**1697 Hwy 2
Site Works Tender**

ADDENDUM NO 3

STANDARD CONCRETE SIDEWALK

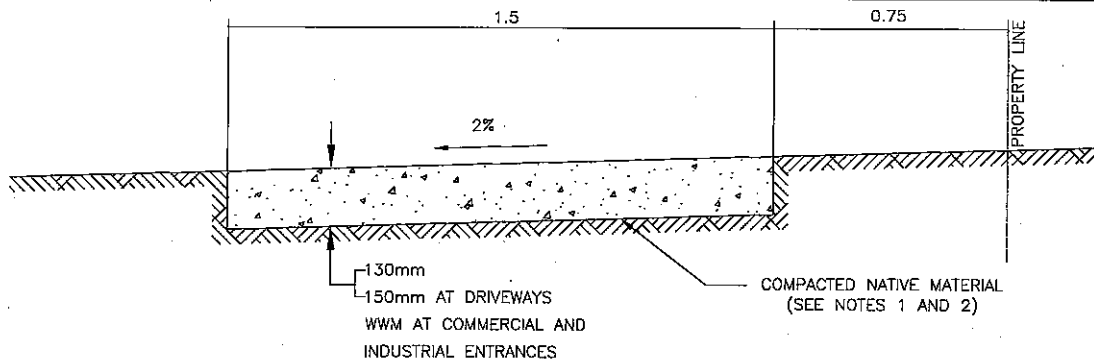
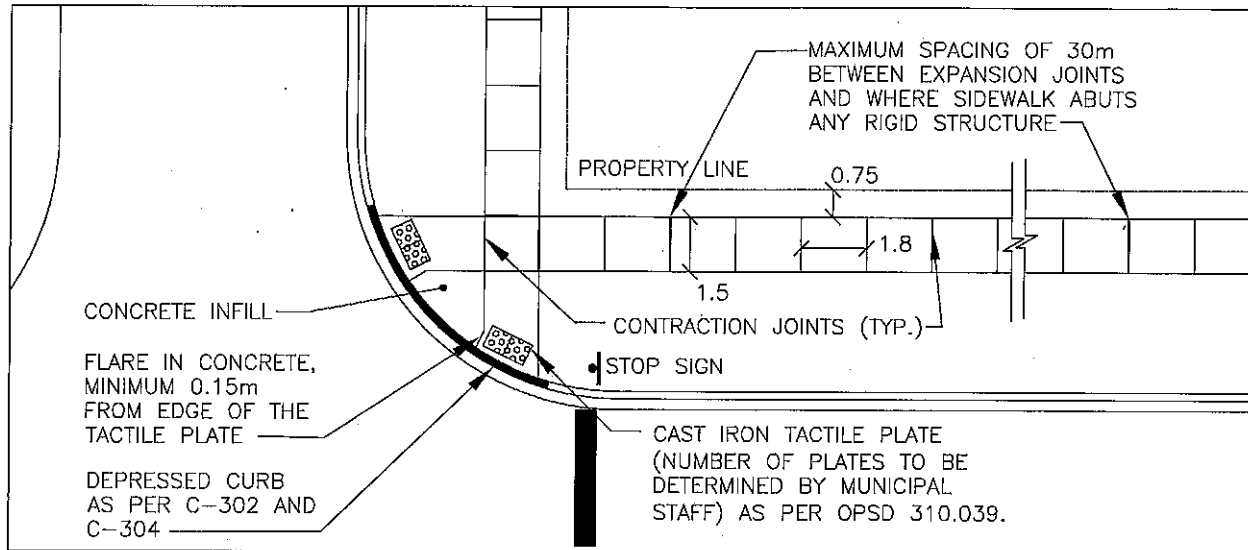
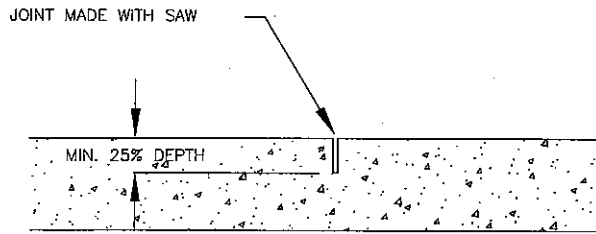
Question: Is there also a detail for the concrete paving?
Answer: *A standard detail of concrete sidewalks can be followed.*

Item 3.2 Standard Concrete Detail attached
